Reference: Oregon State University TRIGA Reactor (OSTR)  
Docket No. 50-243, License No. R-106  
Request for Additional Information (RAI) Regarding License Renewal, Oregon  
State University TRIGA Reactor (TAC NO. MD7360) dated March 19, 2008

Subject: Oregon State University Response to RAI Regarding License Renewal, Oregon State  
University TRIGA Reactor dated March 19, 2008

### Responses to RAI Letter of March 19, 2008

Figure 1: Axial Bulk Coolant Temperature Distribution for 1, 2, & 8 Channel Model  
(HEU Beginning of Life Normal Core)

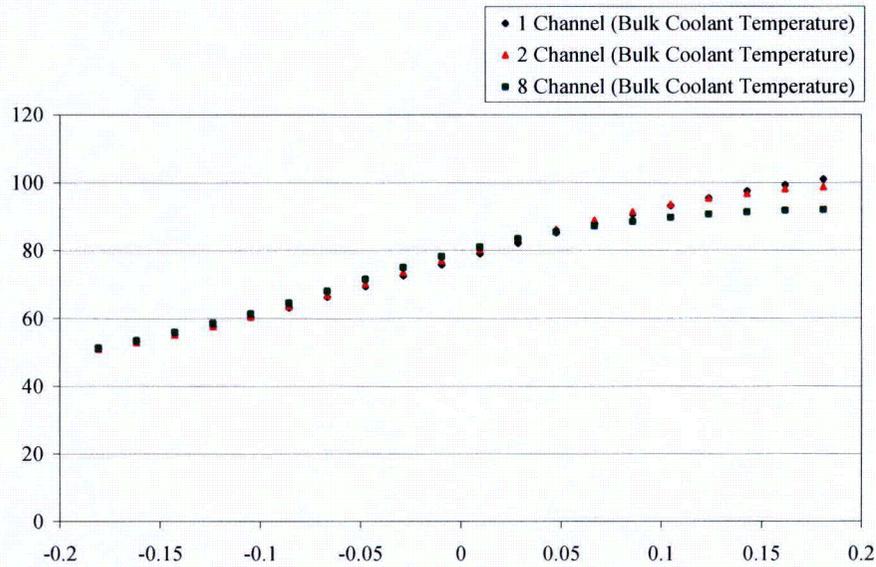
7. Please provide analytical justification for ignoring cross flow between neighboring flow channels.

Figure 1 provides a quantitative comparison of the bulk coolant temperature distribution found in the one, two and eight channel models. This comparison

provides evidence that with an increase in the number of subchannels a corresponding decrease in exit bulk coolant temperature will result as expected. The coolant equilibrium quality and subchannel mass flux are presented in Figure 2 as a function of axial position. These properties, along with system pressure, are the primary parameters for CHF. With an increase in the number of subchannels the mass flux is perturbed greater due to cross flow in the lower axial portion of the core. The equilibrium quality for the single, two, and eight channel models remain similar though the majority of the axial length of the core. As a result of the increased mass flux in the eight channel model near the exit of the subchannel, less energy is deposited into the fluid producing lower equilibrium quality values for the eight channel model relative to the two and one channel models.

Figure 4: Axial CHF Distribution, Correlation Comparison  
(HEU Beginning of Life Normal Core using the single channel model)

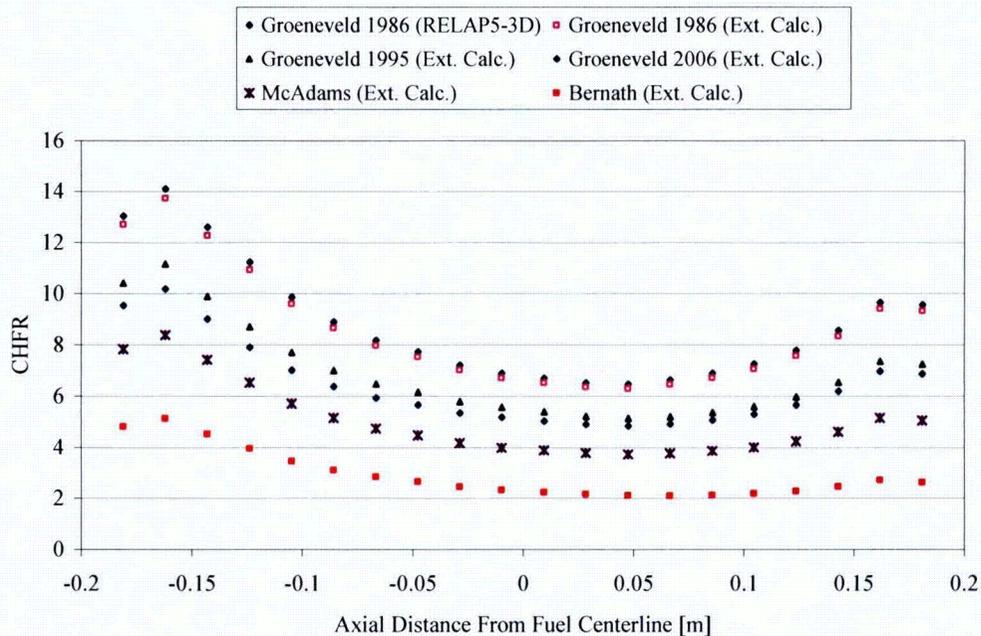
### 10. Why did the thermal analysis not use the Groeneveld Look-up table build into RELAP5-3D?

RELAP5-3D internally calculates the critical heat flux with reference to the 1986 AECL Groeneveld look-up tables. All other correlations were calculated externally using the thermal hydraulic properties resulting from the RELAP5-3D model. In order to verify that these external calculations were being completed in the correct manner, the critical heat flux was calculated externally with reference to the 1986 AECL Groeneveld look-up tables. The result of this comparison is shown in Figure 4. The external calculations produced values that deviated from those conducted in RELAP5-3D by  $\sim 1.0\%$  on the conservative side. The deviation was potentially caused by round off error. Qualitatively, this deviation was estimated to be within an acceptable margin. The axial CHF distribution for the RELAP5-3D internally calculated values as well as all external calculated values are presented in Figure 4.

As presented in Figure 4, the 1986 AECL Groeneveld look-up tables produce the least conservative CHF distribution values, followed by the 1995 and 2006 Tables. The McAdams correlation and Bernath correlation, although having the largest error associated with them, produce the most conservative CHF distribution values. Based on the results presented in Figure 4, the 2006 Groeneveld look-up tables and the Bernath correlation were used in the final version of the core conversion project. They were chosen for the following reasons:

Figure 5 – Comparison of Pulsing from 1 kW and 1 MW

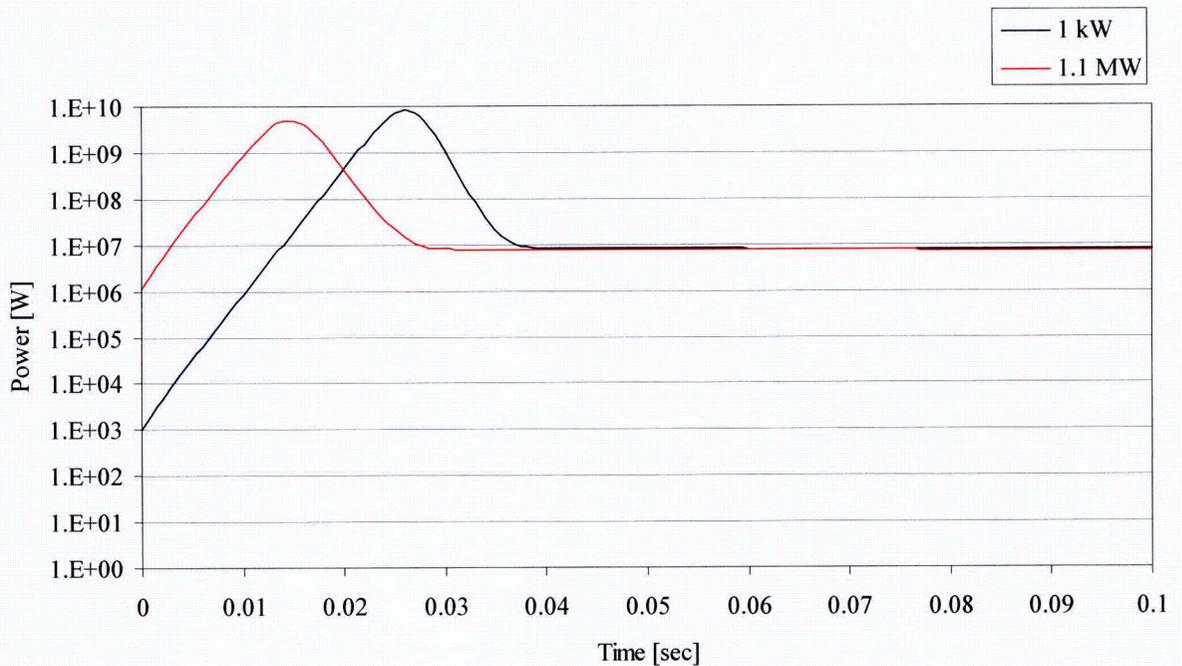
**13. Have the consequences of pulsing the reactor from full power operation been considered? If yes, what are the results; if no, why not?**

The HEU Beginning of Life Normal Core Configuration was analysed for consideration of the potential contingency that the OSTR were pulsed to its licensed limit of reactivity insertion (\$2.55) from its maximum licensed steady state power level (1.1 MW<sub>th</sub>). Figure 5 and Table 1 below summarize the results produced from RELAP5-3D using the HEU Beginning of Life fissile fuel characteristics.

As a result of this comparison it is demonstrated that although the initial steady state power is much greater for the case where the reactor is pulsed from 1.1 MW<sub>th</sub> it results in a lower peak power than that of the 1.0 kW<sub>th</sub> initial steady state power. This is due to the temperature dependant prompt fuel temperature coefficient that is inherent to the OSTR fuel. However, pulsing from 1MW requires both a failure of the 1 kW interlock and a failure of the reactor operator to follow written procedures.
